# Accessibility Building Code Certificate

**Address of Project:** 100 West Commercial

**Nature of Project:** Boat storage and repair

**From:** Kevin Gough <gough@archetypepa.com>  
**To:** Jeanie Bourke <JMB@portlandmaine.gov>  
**Date:** 10/1/2014 11:10 AM  
**Subject:** RE: Canal Landing New Yard  
**CC:** Devin Cough <devin@archetypepa.com>, Stephen Bushey <sbushey@fstinc.com>...  
**Attachments:** A0.00 - COVER SHEET.pdf; A1.01 - FIRST FLOOR PLAN.pdf; A1.02 - SECOND FLOOR-MEZZ. PLAN.pdf; A2.01 - BUILDING ELEVATIONS.pdf; A2.02 - BUILDING ELEVATIONS.pdf; A3.12 - STAIR SECTIONS AND DETAILS.pdf; A4.00 - WALL TYPES.pdf; A4.01 - INTERIOR ELEVATIONS.pdf; A4.02 - INTERIOR ELEVATIONS.pdf

1 | FIRST FLOOR PLAN  
SCALE: 1/8"=1'-0"

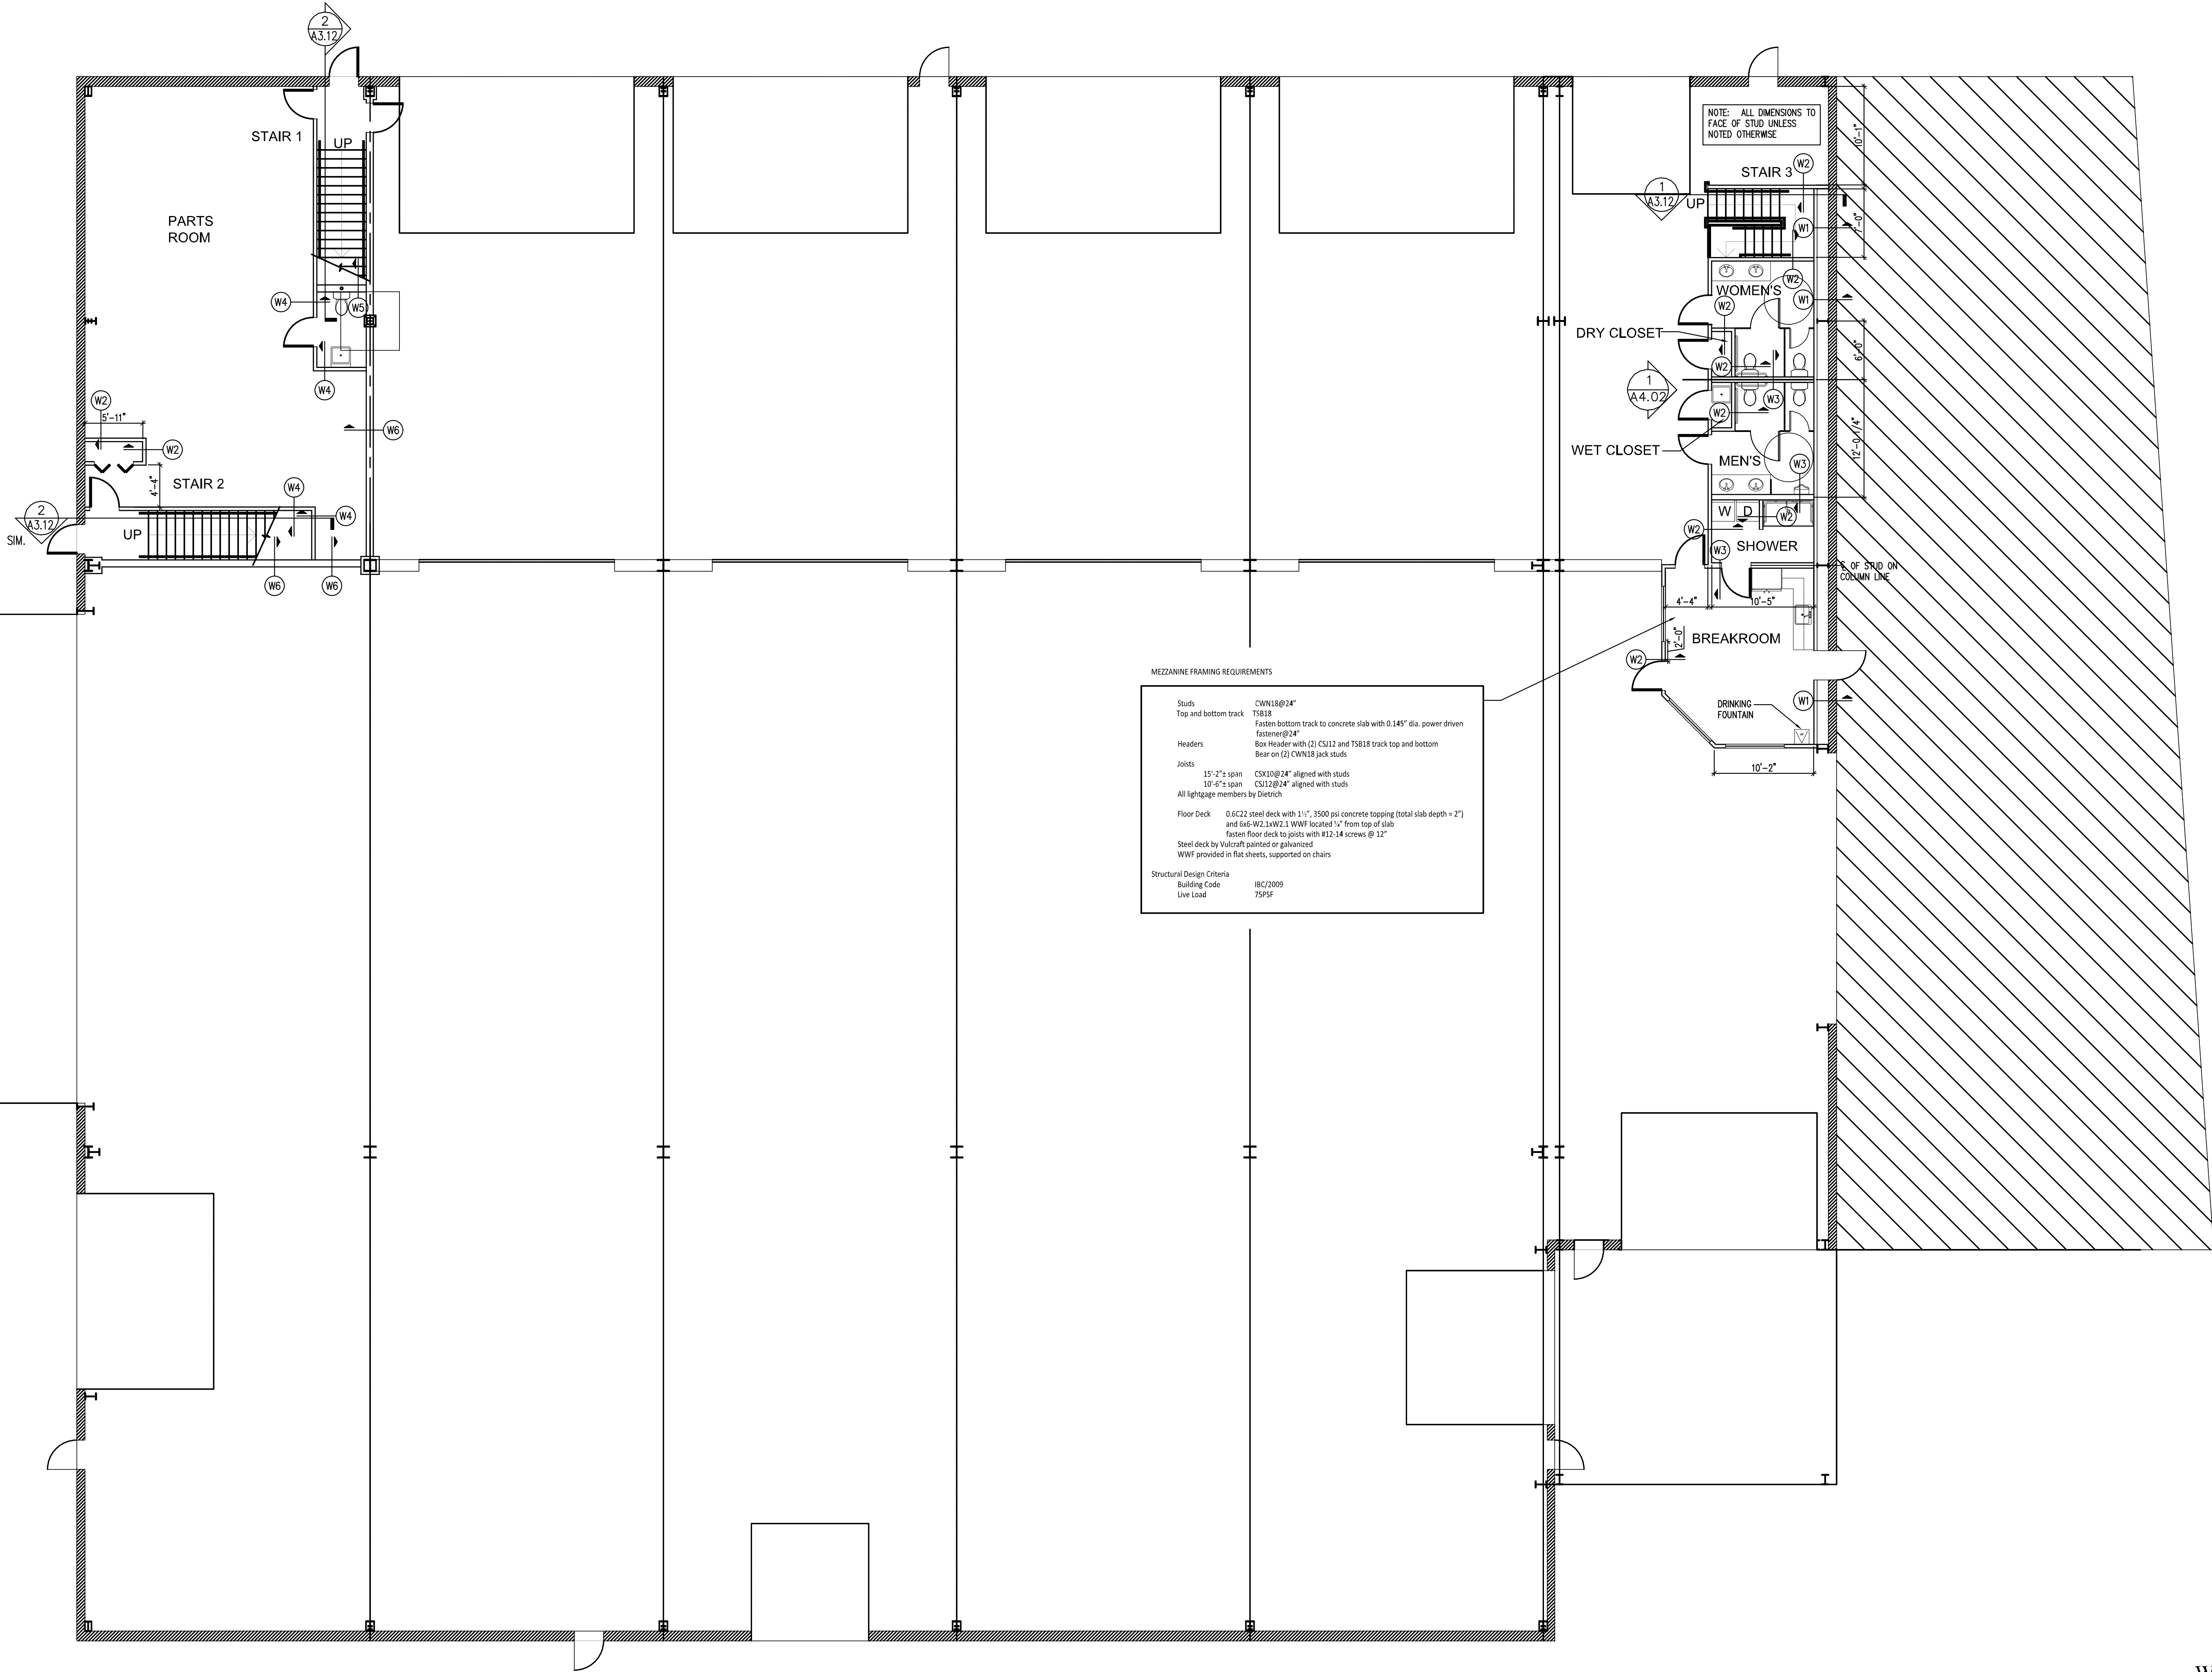
And finally, to address your comment about the occupant loading of the spaces we have labeled "Parts Room" and "Mezzanine" in the Northwest corner, we have noted that these spaces are being designed to be used as storage only at this time. There is no longer an Assembly occupancy portion of the building.

2 | MEZZANINE SECTION  
SCALE: 1/2"=1'-0"

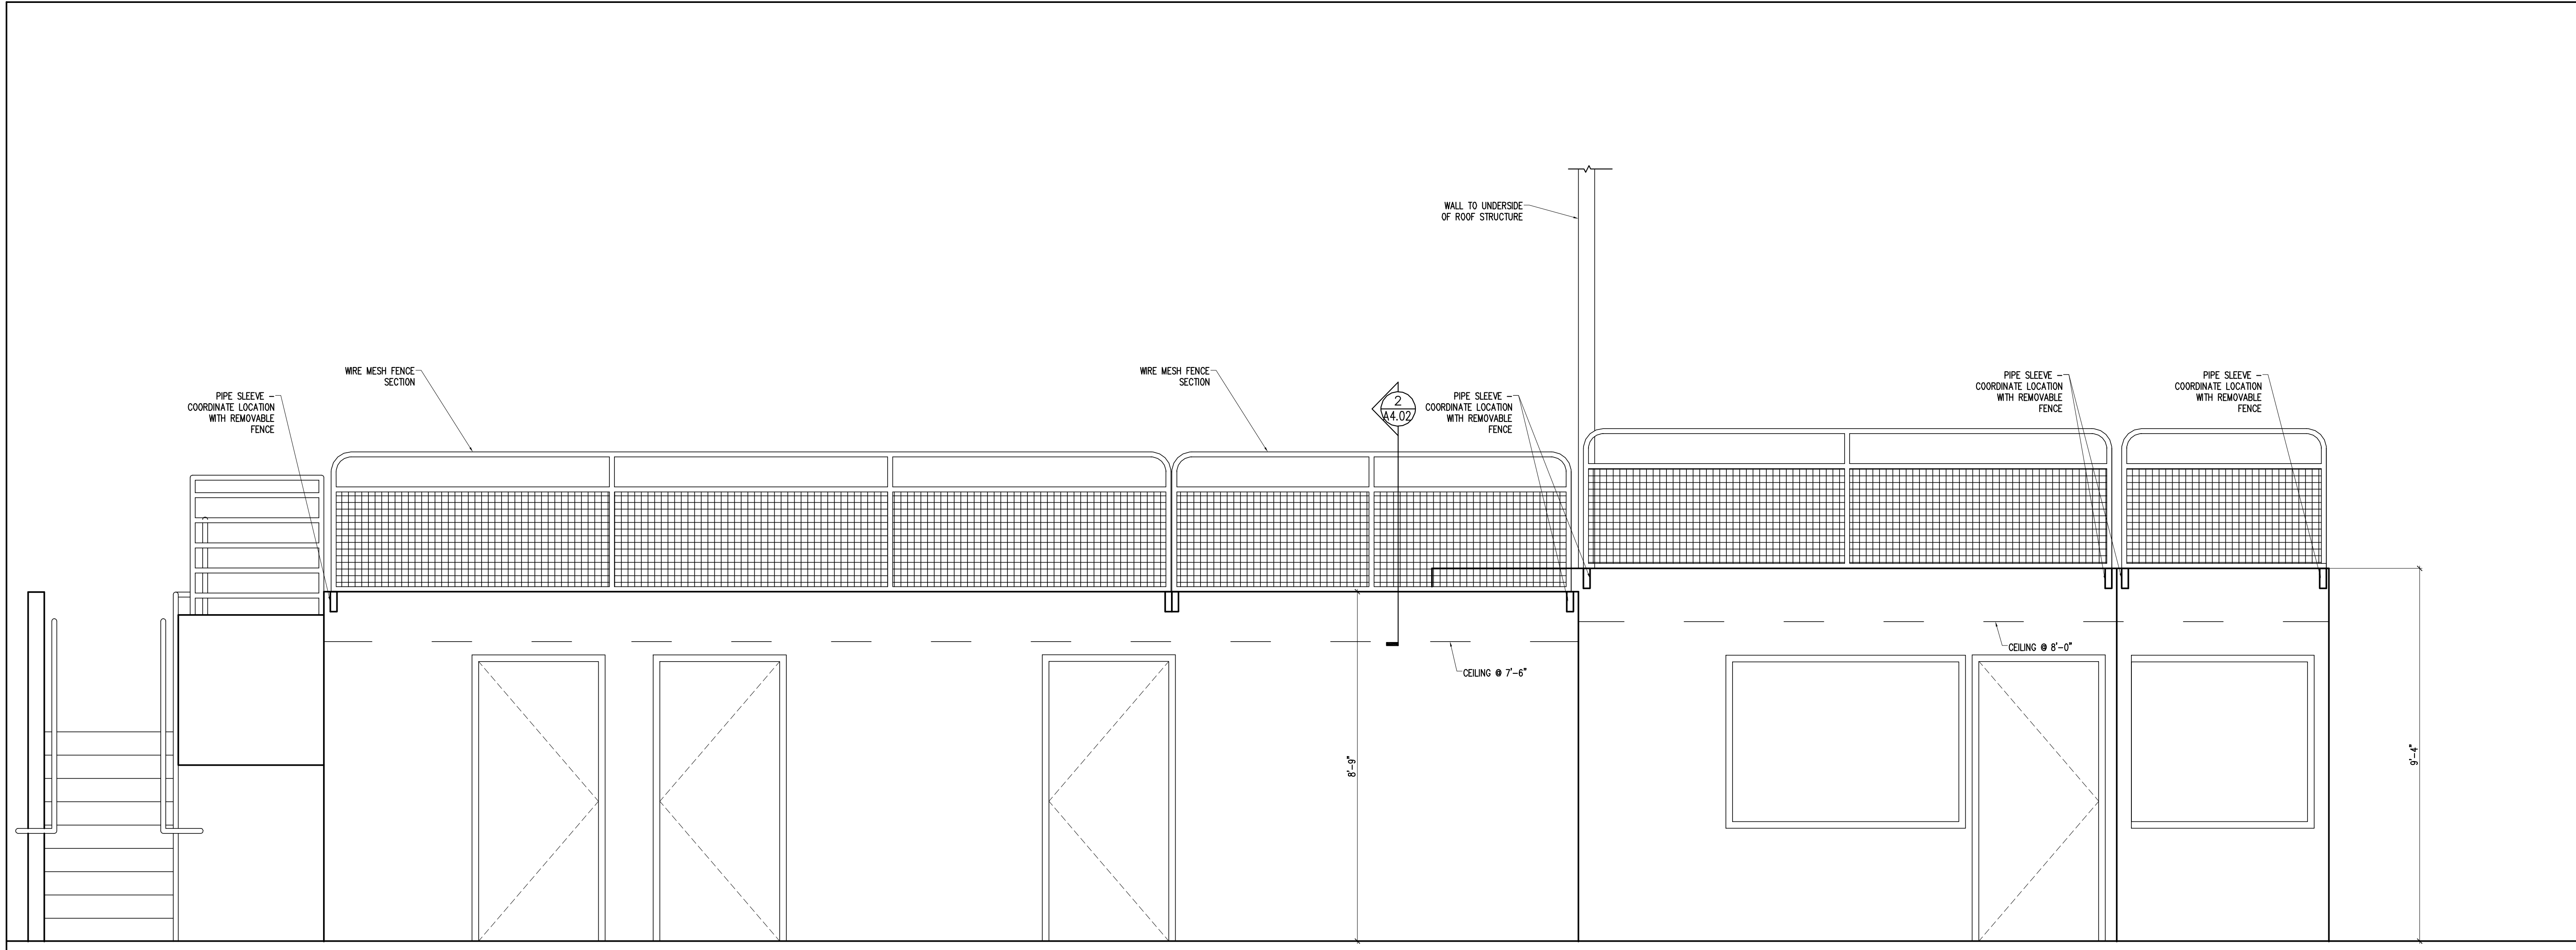
Second, I have a response from David Tetreault regarding your comments on the structural loading at the mezzanine level. His comments follow:

- The live loads of 125 psf and 250 psf noted in IBC Table 1607.1 are for Storage Warehouses (light and heavy storage respectively). I am not certain that this mezzanine area is part of or will be used as a Storage Warehouse. If it is, the Owner should provide a determination as to whether it is to be used as heavy or light storage.

- I am available to revise the design for either of the Storage Warehouse loadings noted in IBC Table 1607.1 if the building official does not agree with the method used for determining the 75 psf criteria. If that is the case, please advise as to whether heavy or light storage loading should be used.
